RE: Item 12.5 - Biking Infrastructure Enhancement along Main Street East from Queenston Traffic Circle to Parkdale Avenue

Looking westbound on Main Street East:

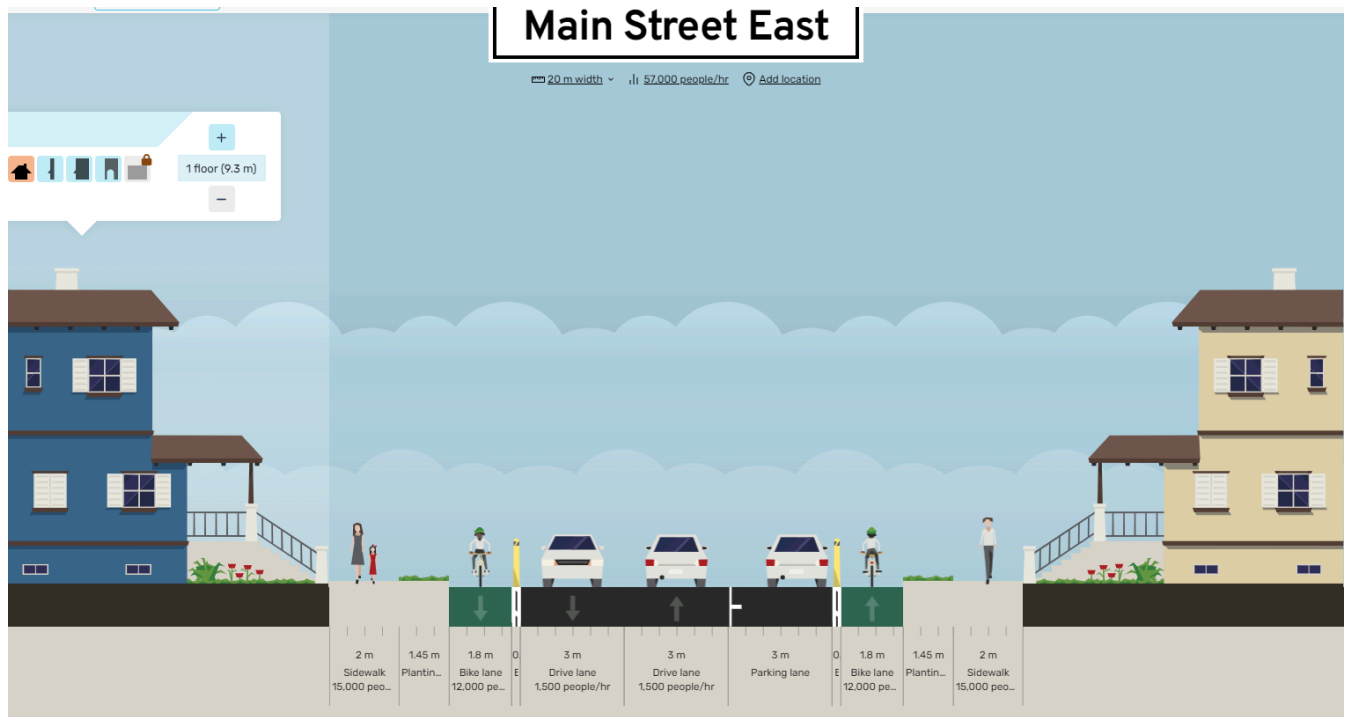
Cycle Hamilton would also like to recommend that instead of cycling infrastructure only on the south side of Main Street East as noted in the motion, that it instead be installed on both the north and south side of the street as this is preferred to provide safer space for people on bikes. The existing asphalt surface is approximately 13m-14m wide which provides plenty of space for many road configurations. An alternative configuration provides the following benefits:

Cycle Hamilton's recommended road configuration is as follows:

Cycle Lane	Protection	Eastbound Vehicle Lane	Westbound Vehicle Lane	Parking/ Drop-off Lane	Protection	Cycle Lane	Total
1.8m	0.3m	3.0m	3.0m	2.7m	0.4m	1.8m	13m
